SECTION 4.55(1A) APPLICATION TO AMEND SSD 8114 | MOD 5 LINDFIELD LEARNING VILLAGE

The application proposes to modify Condition A2 of SSD 8114 to incorporate additional architectural plans for Phase 2 and 3 to allow the relocation and consolidation of rooftop plant services and the installation of screening devices. The rooftop plant has been installed in the current location to support the effective operation and occupation of the building.

Figure 1 Rooftop plant screens elevations

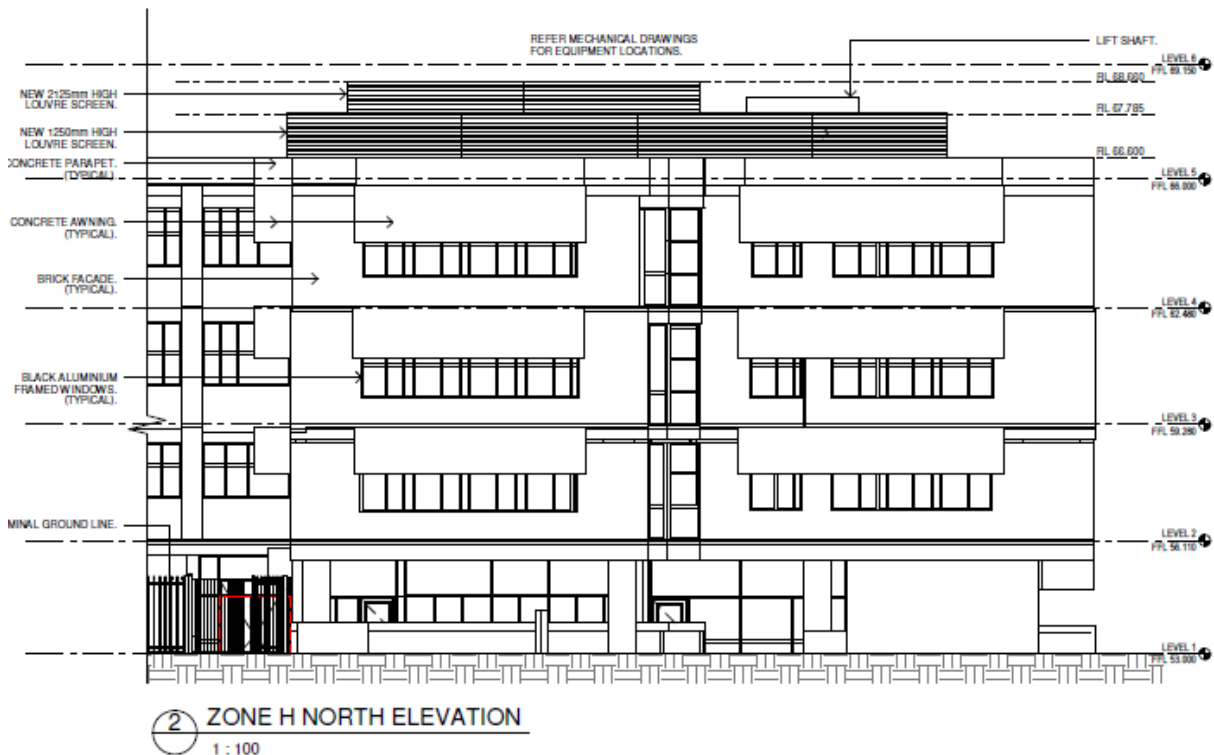
- Relocation and consolidation of rooftop services including condensers and all associated equipment runs and plinths in two locations on the roof of the development;
- Amend all duct work to be kept below 1200mm height;
- Construction of concrete footings 200mm in height at north-western extent of the development as shown on the drawings;
- Three steel and aluminium louvred screens to be affixed to concrete blocks to a height of 1250mm (X2) and 2125mm (X1) at north-western extent as shown on drawings. The louvres are proposed to be painted in Dulux 'Shale Grey'.

Figure 2 Existing view (left) and proposed relocated rooftop plant with screens (right).

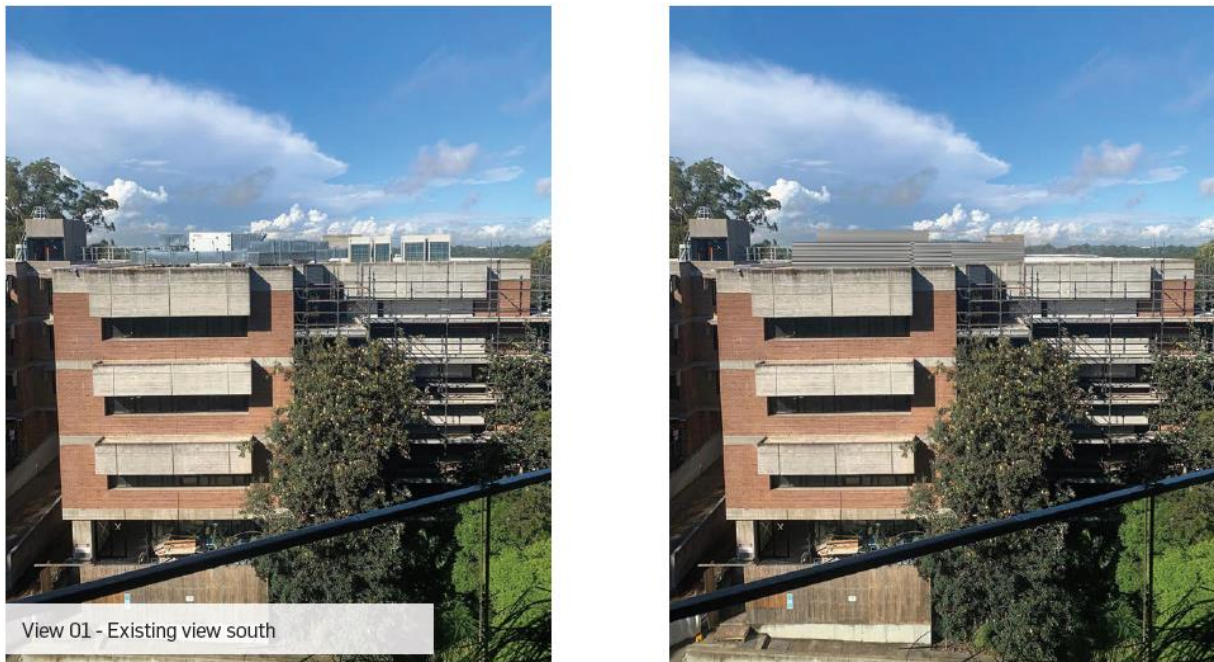
The proposed roof plant has been installed in two locations on the existing building as part of the development for the Lindfield Learning Village. The roof plant was installed in the current location to support the effective operation and occupation of the building. The purpose of the louvred devices is to screen the rooftop plant for aesthetic reasons in response to concerns raised by residents from the residential development to the immediate west.
